AMENDMENTS TO THE DRAWINGS

REMARKS

FIG. 1
(PRIOR ART)

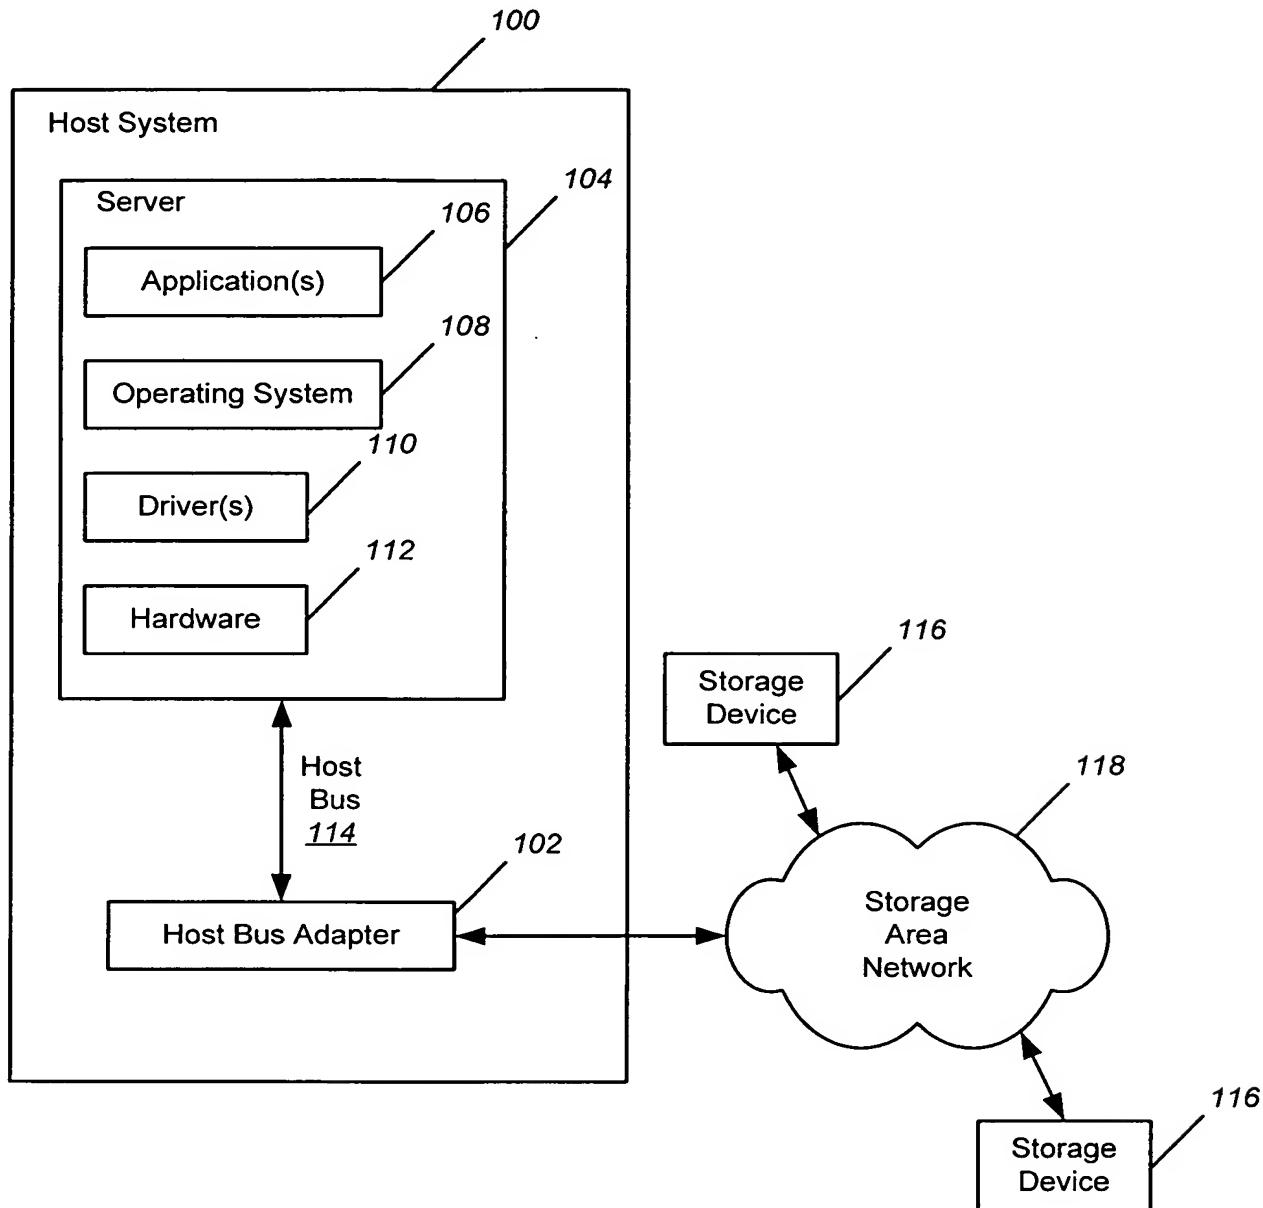
The drawings were objected to because of missing reference numbers and "Prior Art" designations. In particular, FIGs. 1 and 2 were objected to because they were not labeled as prior art, and FIG. 3 was objected to because references 302 and 304 were missing. FIGs. 1 and 2 have been amended to include a "PRIOR ART" label, and FIG. 3 has been amended to add the missing references. With these amendments, it is respectfully submitted that the objection to the drawings has been overcome.
